Upgrade of Ortlinghaus Clutch & Brake

For further details about this upgrade of the Ortlinghaus Clutch & Brake Unit please contact either of the contacts below quoting Technical Bulletin Number **TB5000-042**

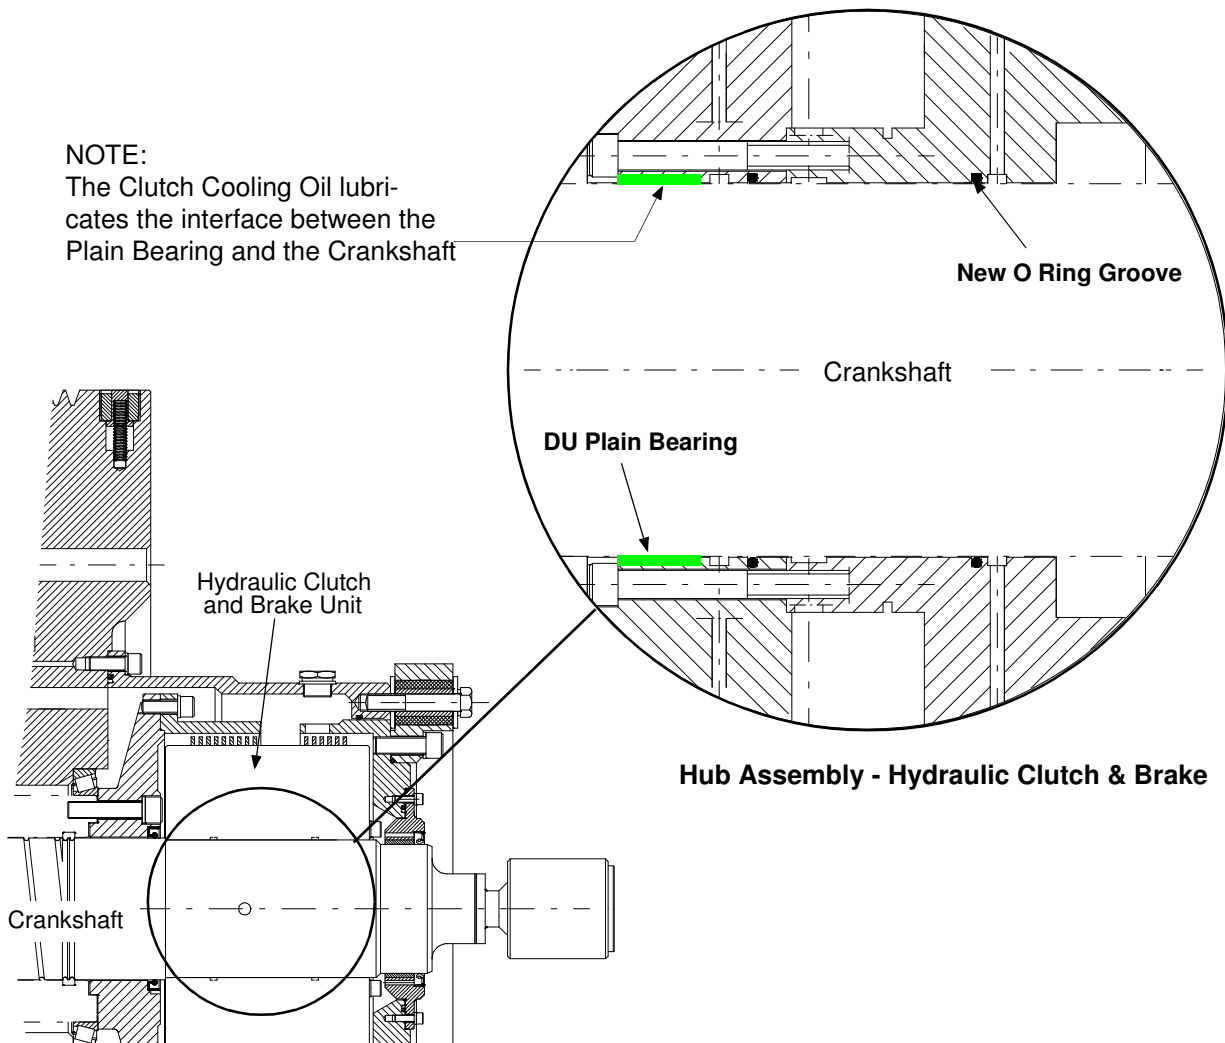
Summary: CarnaudMetalbox Engineering have introduced an anti - fretting Bush to the Hub of the Ortlinghaus Clutch & Brake.
This Bush is located in the Clutch & Brake Hub Assembly and is intended to stop fretting of the Hub bore with the Crankshaft diameter.

This modification will be incorporated on all new Ortlinghaus Clutch and Brakes. It will also be part of the refurbishment of existing Clutch & Brakes ordered through CarnaudMetalbox Engineering
